City Planning Department

Memorandum- REVISED 2.28.25

To: Cranston City Plan Commission
From: Grace Brownell | Planner Technician
Date: February 26, 2025
Re: 175 Farmington Ave.- Assessors Plat 8, Lot 1022
Application for Dimensional Variance

Request:
To amend the previously granted variance for this property due to the submission of changed Building Plans to the Building Department. The previous granted relief specifically related to lot size and frontage. The Applicant now is additionally requesting relief for building height. (17.20.120 – Schedule of Intensity Regulations and 17.92.010 – Variances).

NEW SITE PLAN

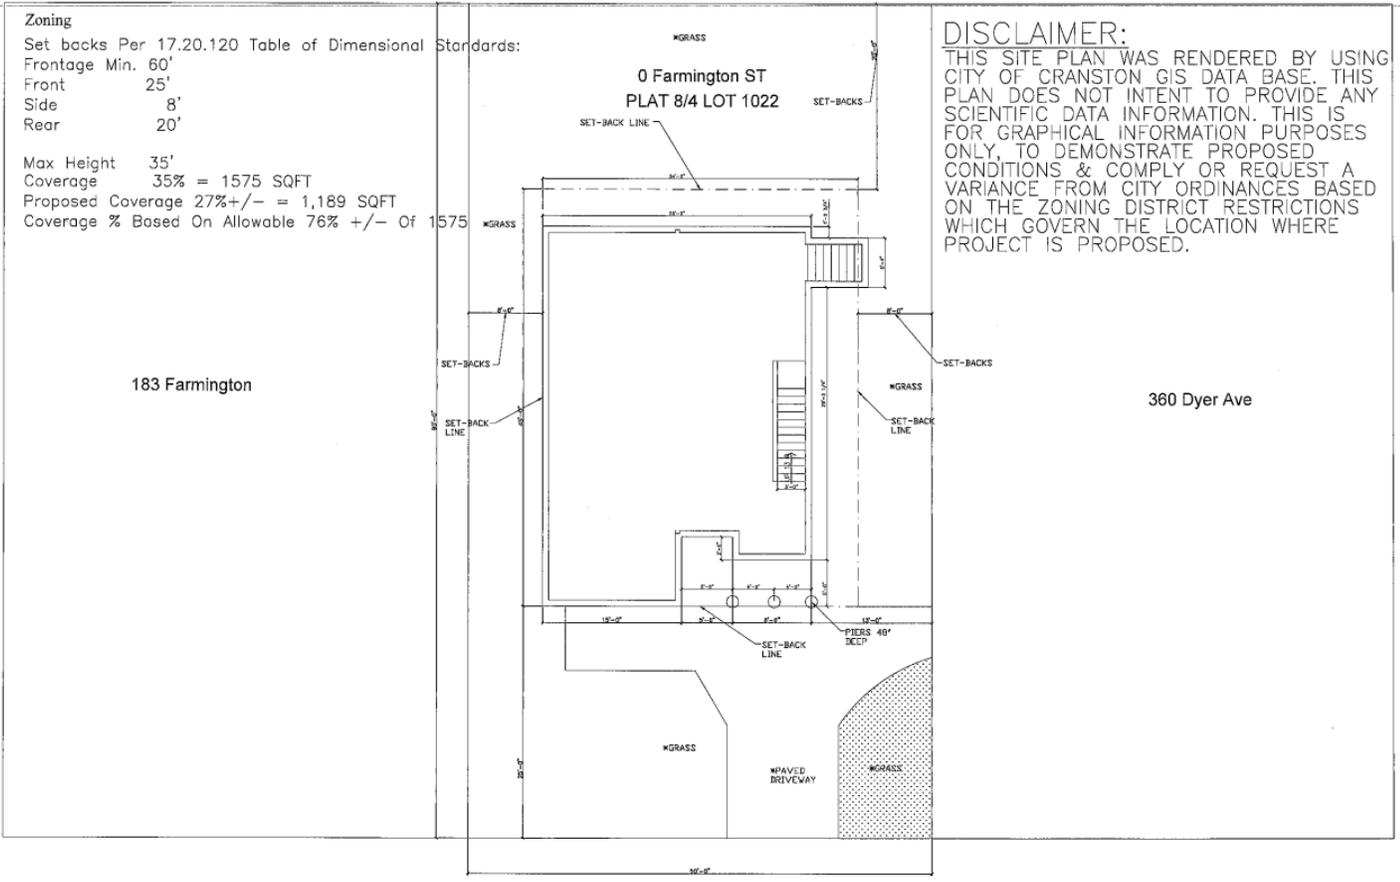
- Building Height
 - Required: 35'
 - Proposed: 35'8"
 - Relief Requested: 8"
- Staff finds the proposed single-family house was built within all required setbacks for a B-1 zone. The resulting lot coverage is 27%, which also complies with the 35% coverage limit for this zone.

ELEVATIONS

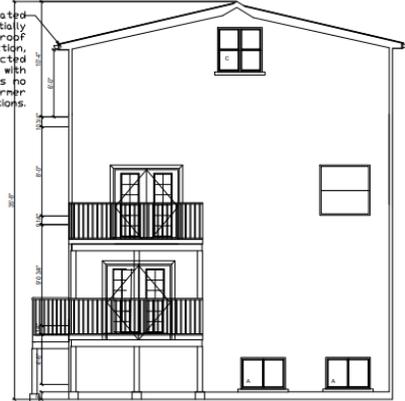
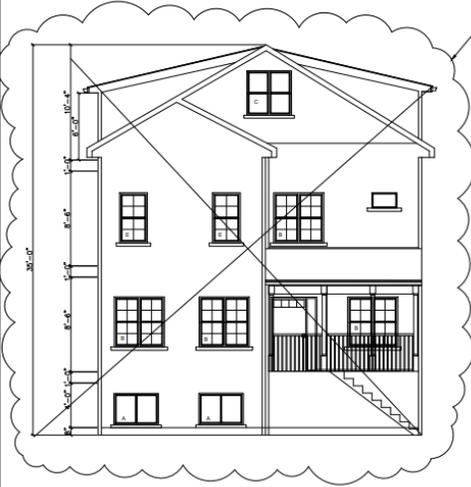
Building deviated from initially depicted roof construction, and constructed top floor with 6' walls no dormer conditions.

Building deviated from initially depicted roof construction, and constructed top floor with 6' walls no dormer conditions.

Design Consultant depicted restricted dormers with sloped rafters to top of SubFloor at attic space.

Building deviated from initially depicted roof construction, and constructed top floor with 6' walls no dormer conditions.
